To: Plan Holders for Improvements to the
Kirksville Regional Airport
Kirksville, Missouri
MoDOT Project No. 14-028A-4
Schedule I: Rehabilitate Wildlife Perimeter Fence

**ADDENDUM NO. 3
TO
CONTRACT DOCUMENTS, PLANS AND SPECIFICATIONS
FOR IMPROVEMENTS TO THE
KIRKSVILLE REGIONAL AIRPORT
KIRKSVILLE, MISSOURI
MoDOT PROJECT NO. 14-028A-4**

REHABILITATE WILDLIFE
PERIMETER FENCE

FENCE DETAILS

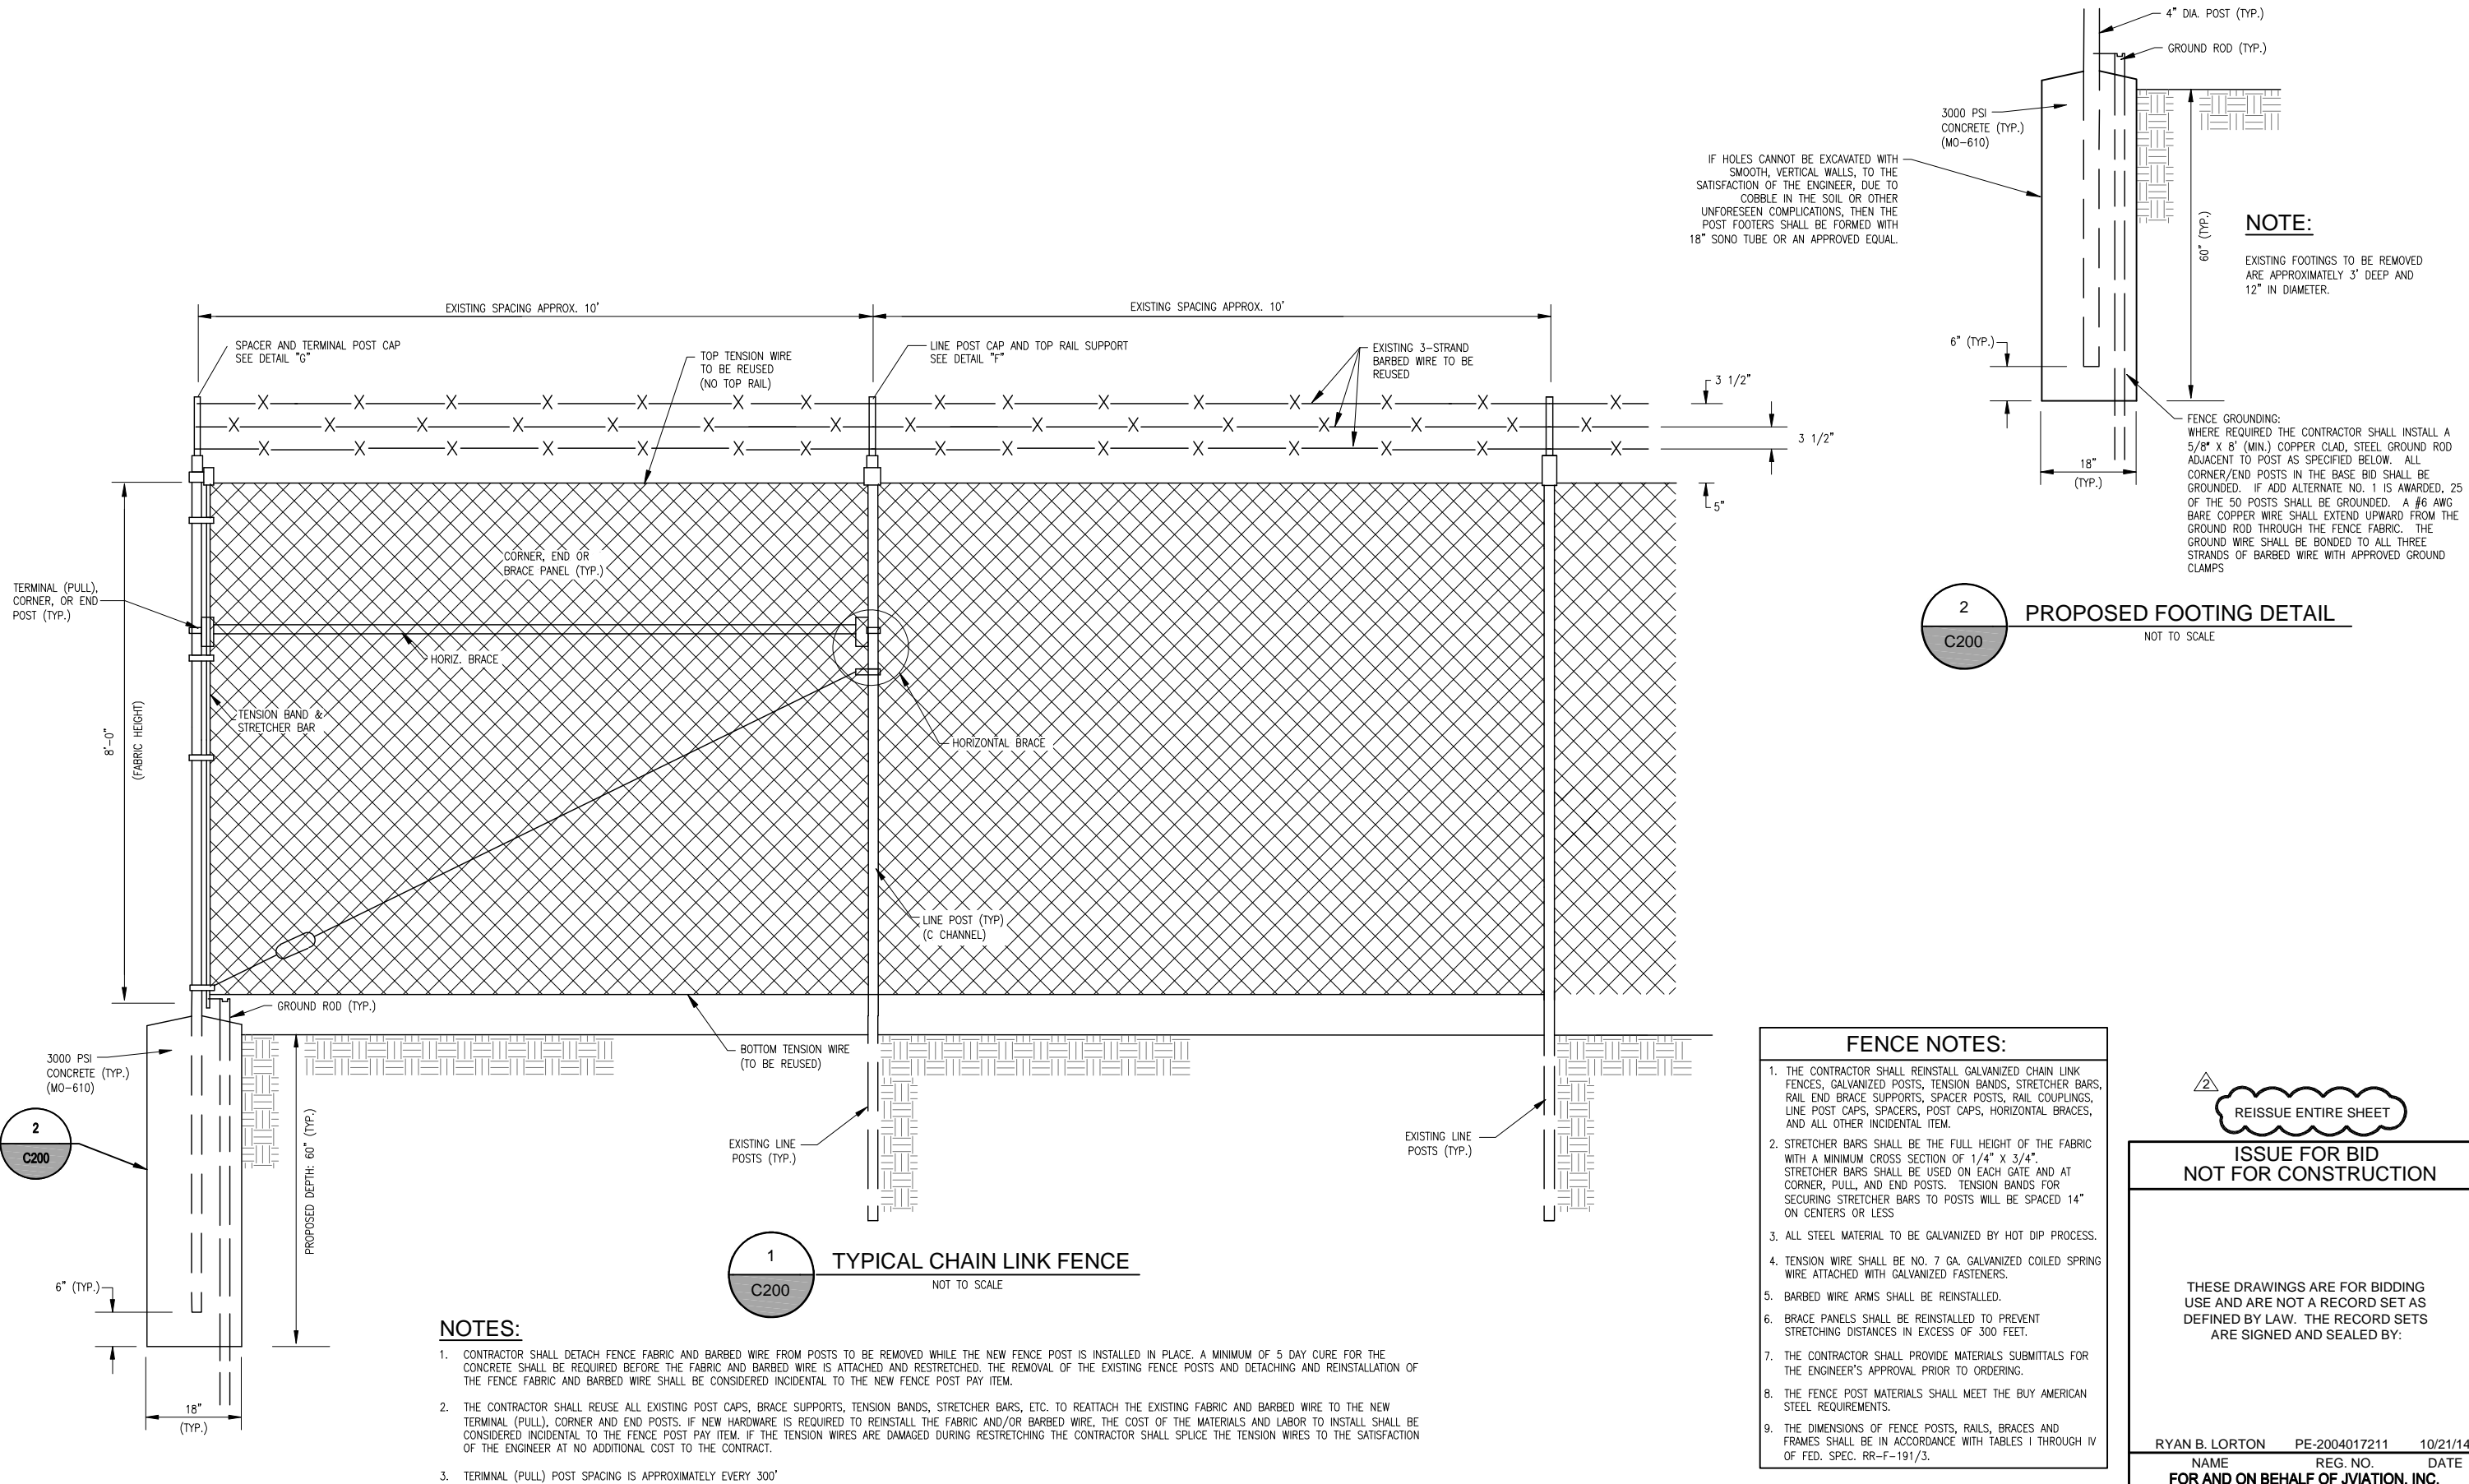
Sheet: G004
Sheet Number: 6 of 6
Revision: See attached revised sheet dated November 4, 2014, that clarifies the following:

- All proposed fence posts shall be 4" diameter. See revised "PROPOSED FOOTING DETAIL".
- Existing top and bottom tension wires to be reused. See revised "TYPICAL CHAIN LINK FENCE" detail.
- If tension wires are damaged during restretching the Contractor is required to splice the wires to the satisfaction of the Engineer at no additional cost to the Contract. See the revised NOTE 2 under the "TYPICAL CHAIN LINK FENCE" detail.
